**CONTRACT :** Plot 18 by Dorchester Collection

**Material Description:** Material Delivery Inspection Request for Custom Fabricated Kitchen Equipment as per the attached DO No. ELE-DC-010223 and approved custom fabrication drawing.

## SHOP DRAWING

Project:	Contractor / Package	Document No.	Revision
Plot 18 by Dorchester Collection	Khansaheb Civil Engineering LLC	ELE-AX-SD-B1-01005	01
To: Khansaheb Civil Engineering	Omniyat Middle East Real Estate Development LLC	Submittal Issue Date:	29.08.2022

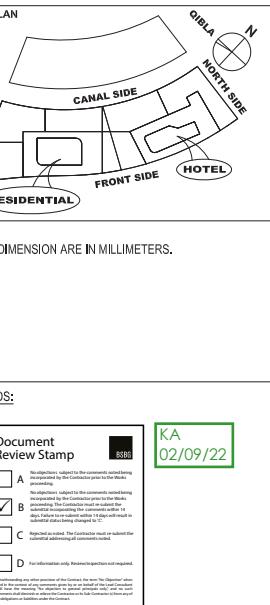
<b>Consultant Review Comments:</b>	<b>Digital Stamping</b>
Fondue:- Refer Fondue comments on attached dwg

**ON DUE COMMENTS ON CONSTRUCTION DETAIL ON THIS DRAWING WILL BE TYPICAL FOR ALL FABRICATION ITEMS ON HIS PROJECT UNLESS COMMENTED OTHERWISE.**

Comply with Fondue comments on sample inspection report

Each cupboard section to be lockable

Two removable mid Shelves

Comply with Fondue comments on sample inspection report

Each cupboard section to be lockable

Provide additional vertical support brackets

Provide additional vertical support brackets

Refer and comply with Fondue comments on sample inspection report

Refer and comply with Fondue comments on sample inspection report

DRAWING NO.	ELE-AX-SD-B1-04005	REV.	00

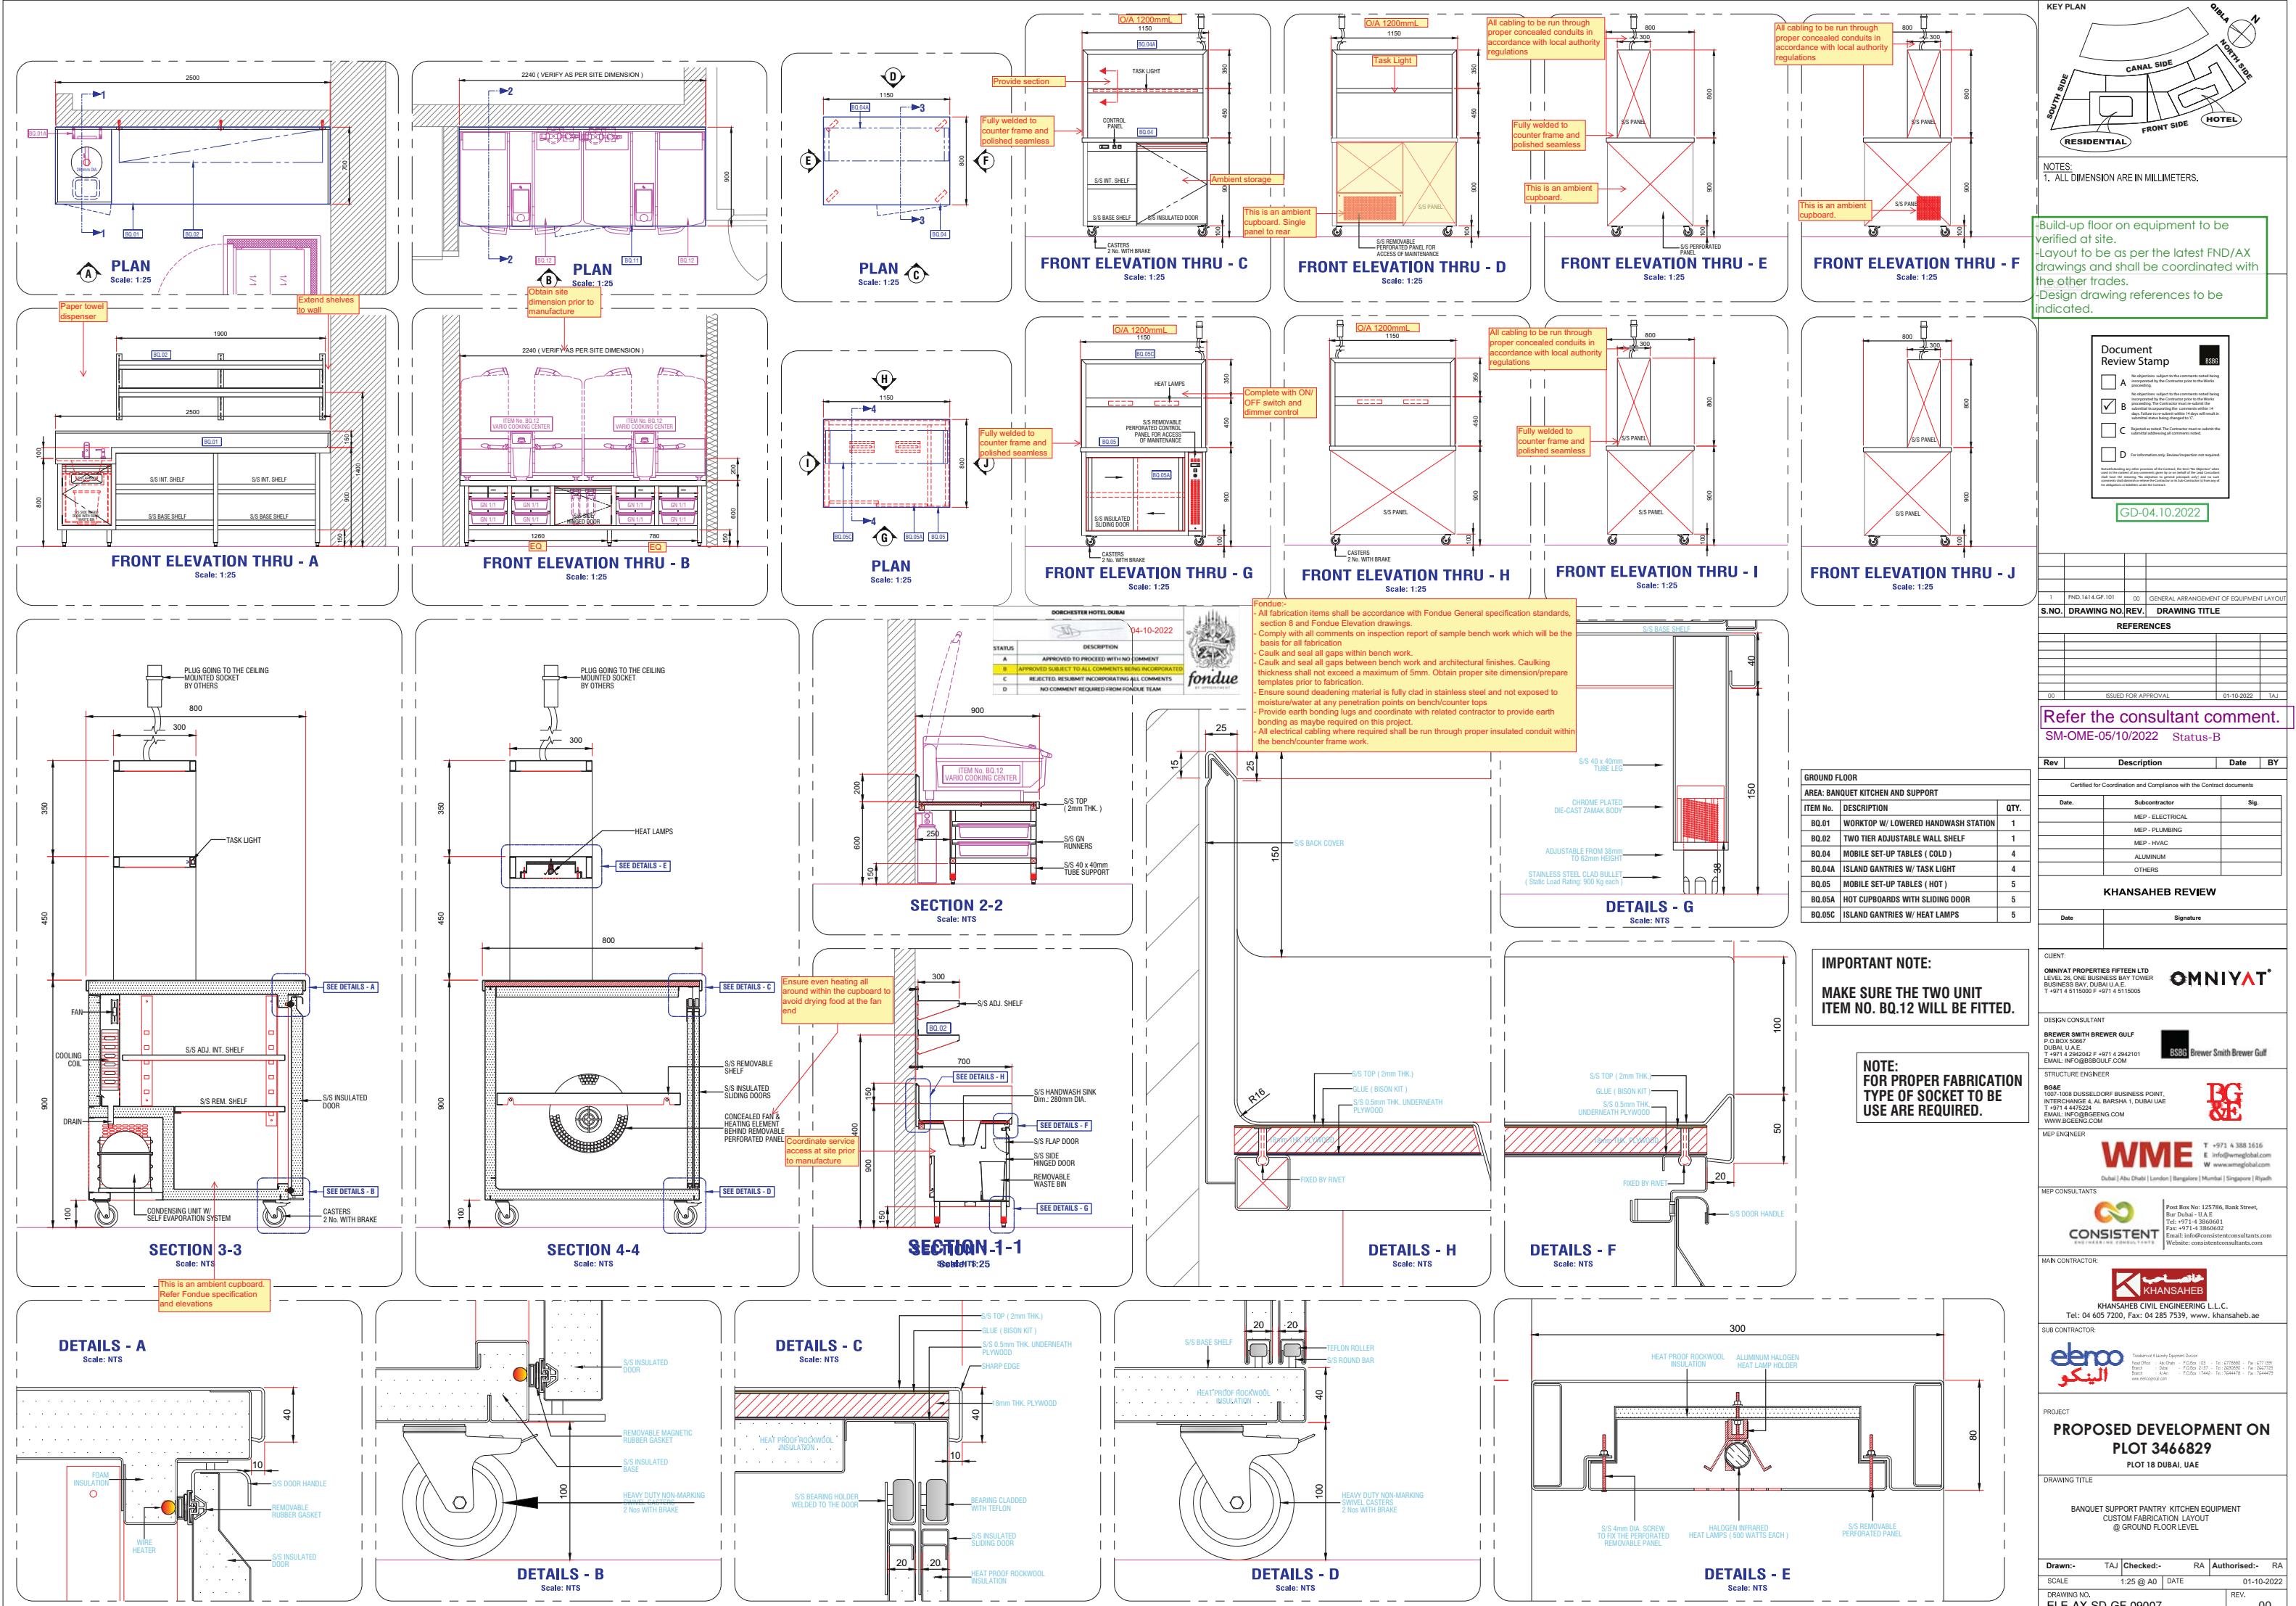
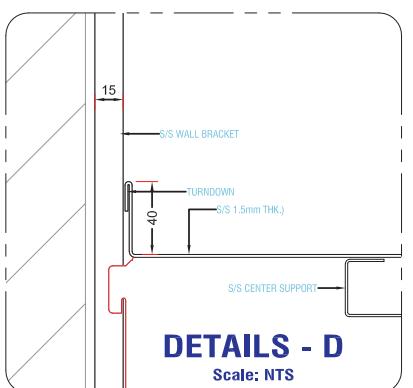
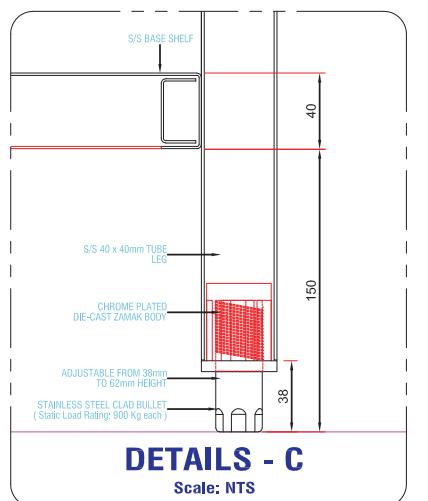
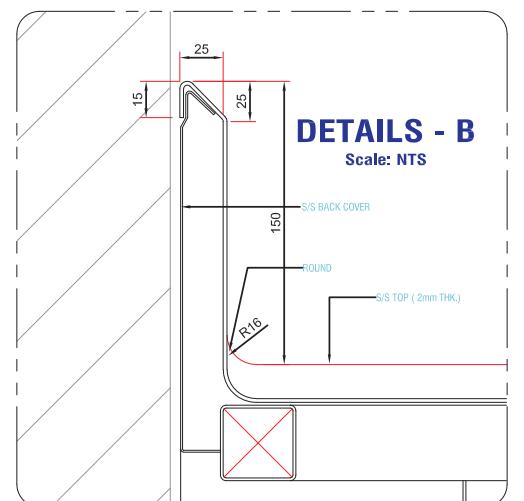
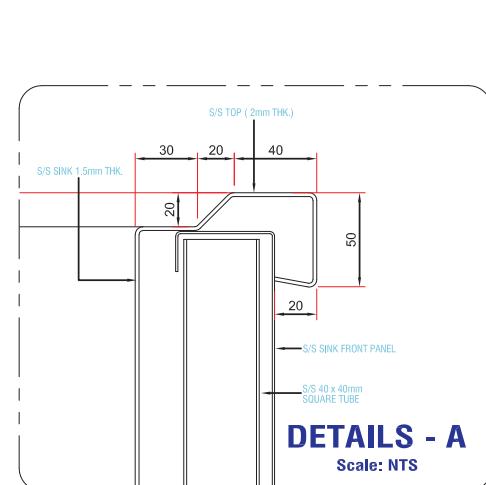
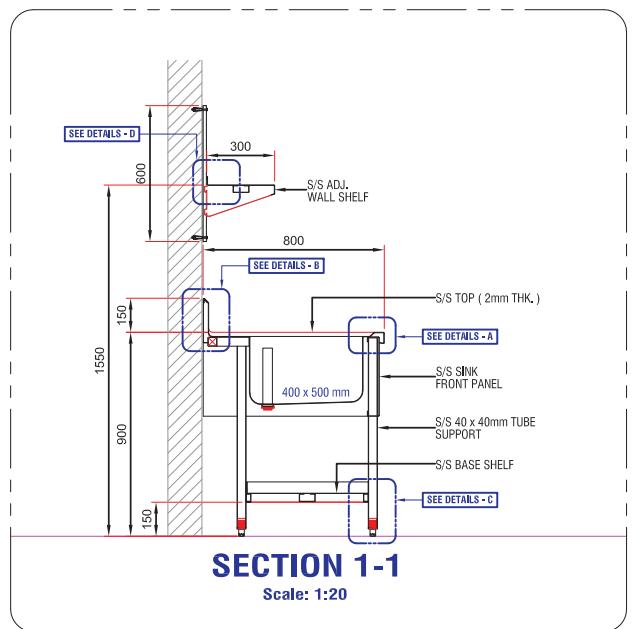
<b>Consultant Review Comments:</b>	<b>Digital Stamping</b>
Fondu:- Refer Fondu comments on attached dwg	
Name.....	George K
Signature.....	
Date.....	01-09-2022

Refer Fondue Comments on construction details on dwg ELE-AX-SD-B1-01005-01

- Build-up floor on kitchen equipment to be verified at site.
- Layout to be as per the latest FND/AX drawings and shall be coordinated with the other trades.
- Design drawing references to be indicated.

Project:	Contractor / Package	Document No.	Revision
Plot 18 by Dorchester Collection	Khansaheb Civil Engineering LLC	ELE-AX-SD-GF-09008	00
To: Khansaheb Civil Engineering	Omniyat Middle East Real Estate Development LLC	Submittal Issue Date:	01.10.2022

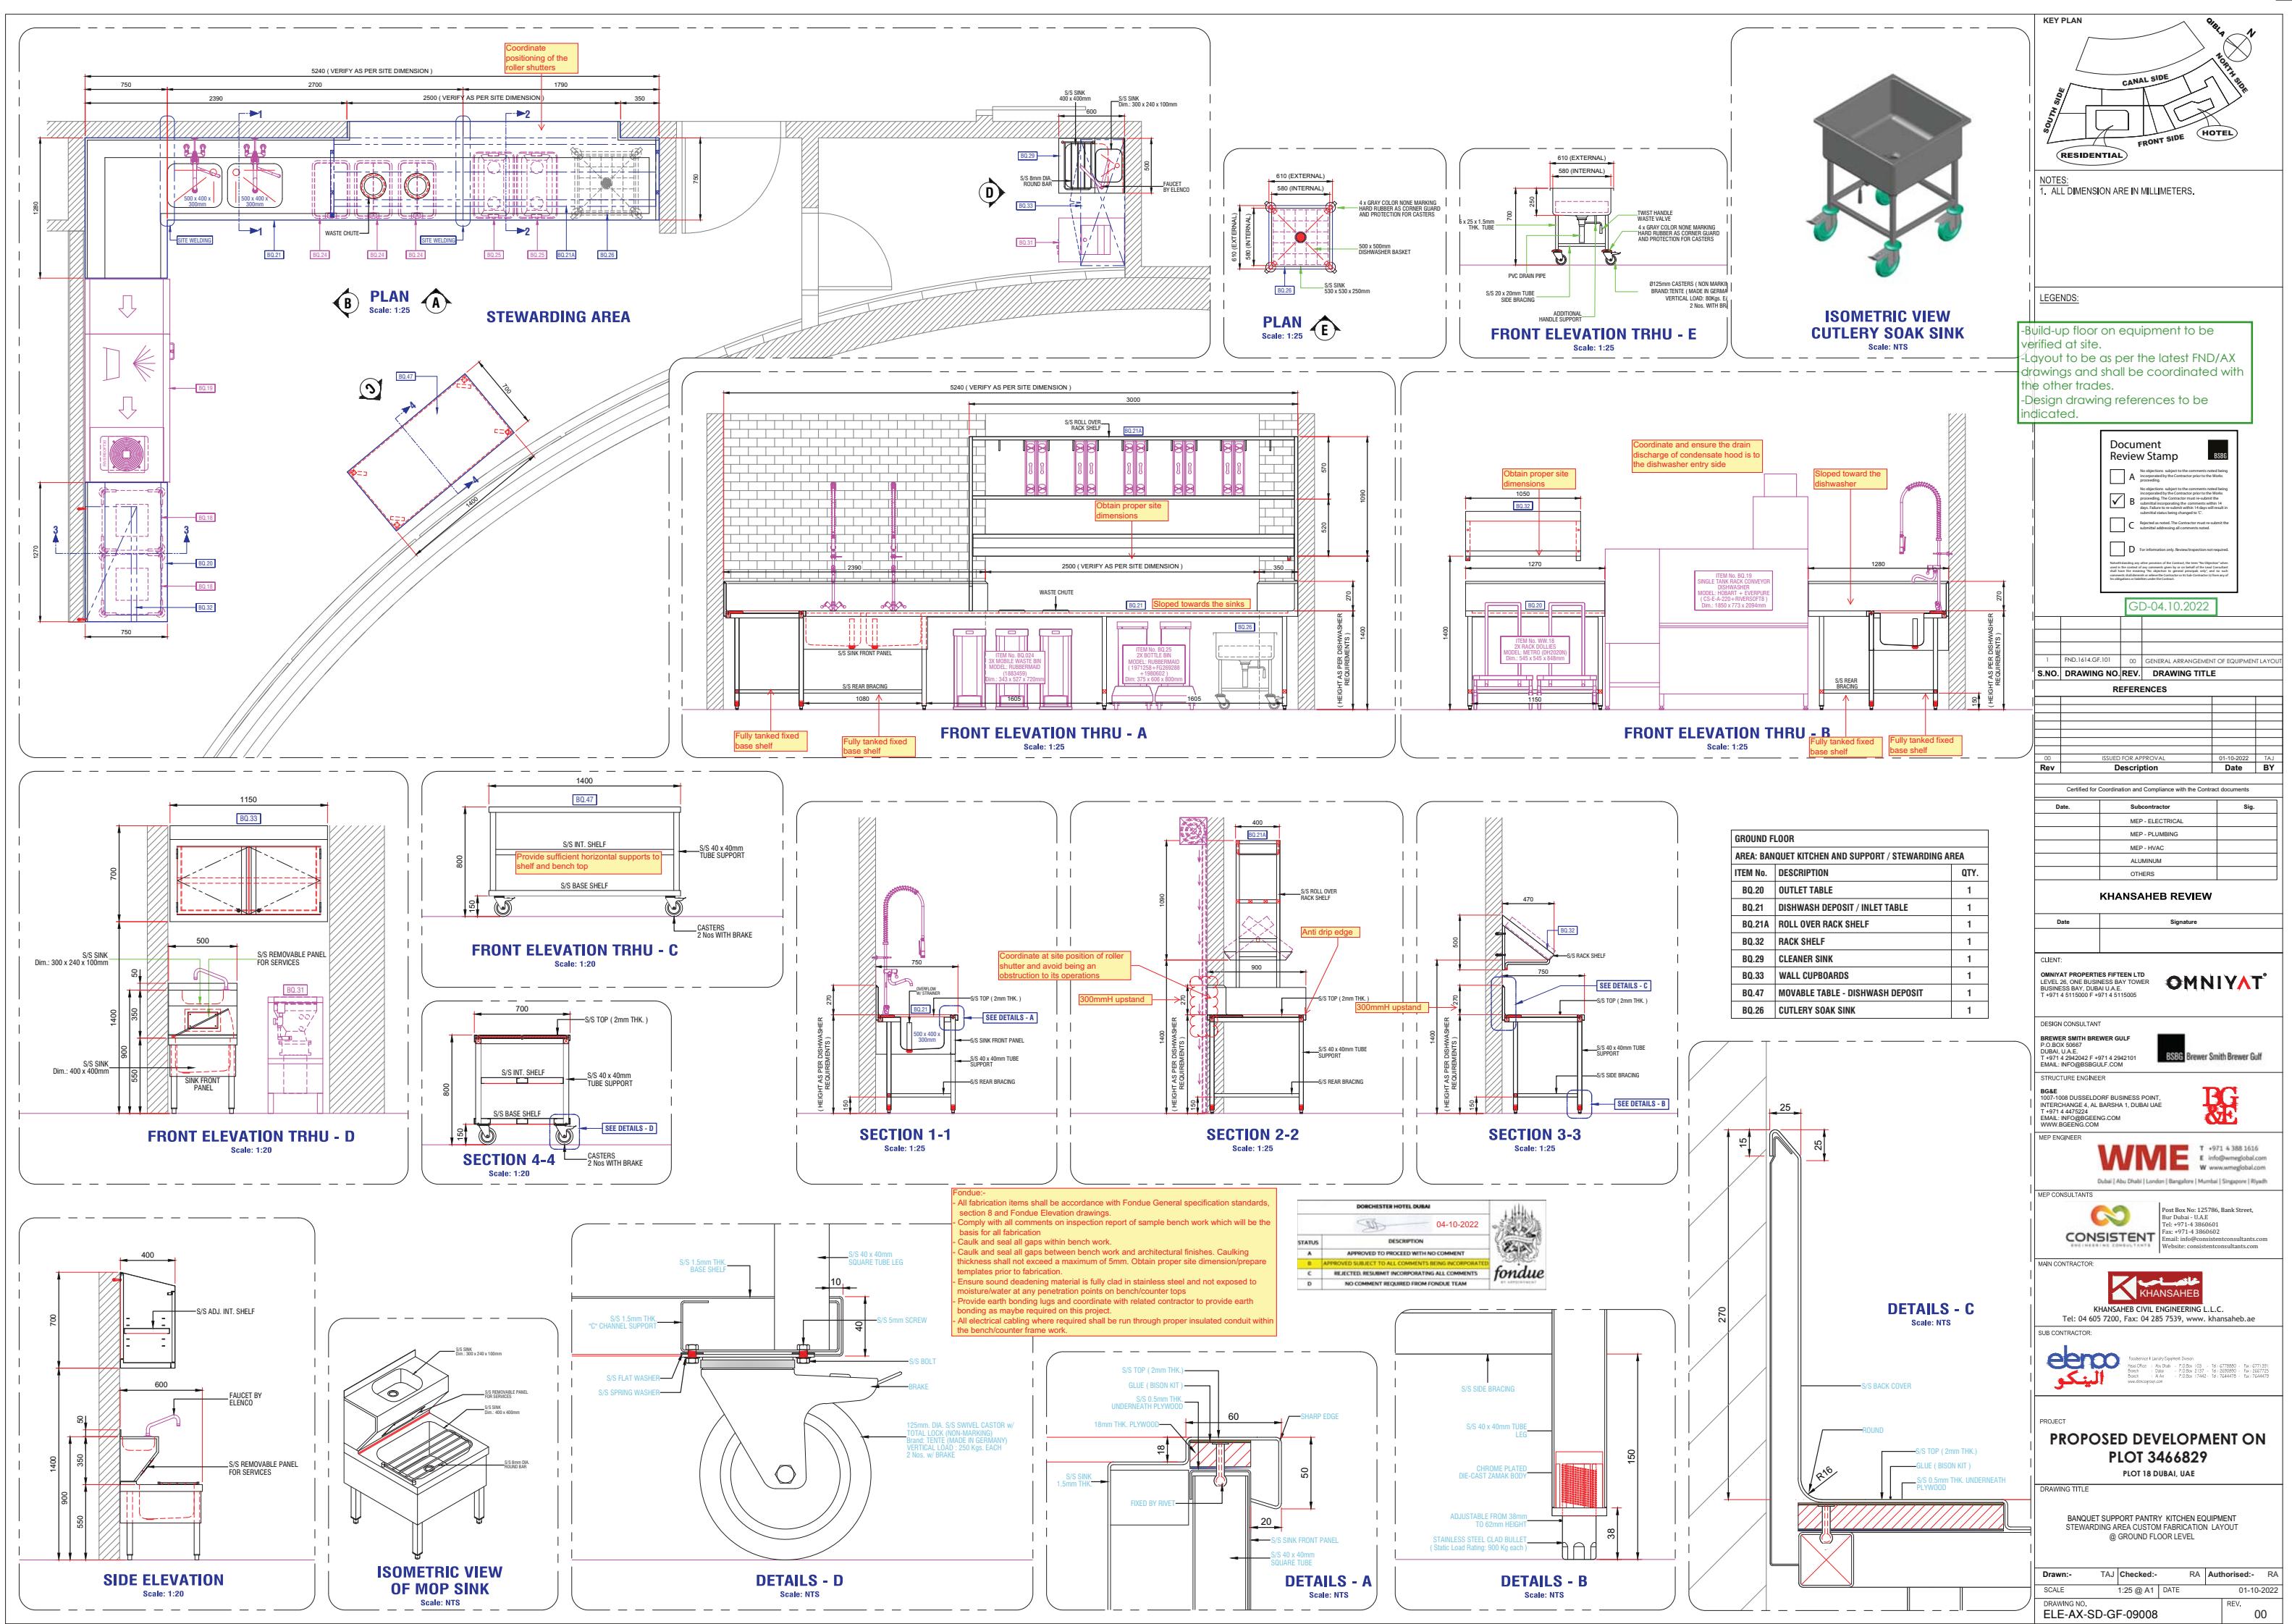
Consultant Review Comments:	Digital Stamping
Fondue: Refer Fondue comments on attached dwg

Lead Consultant Review Comments:	Digital Stamping
Refer comments on the drawing
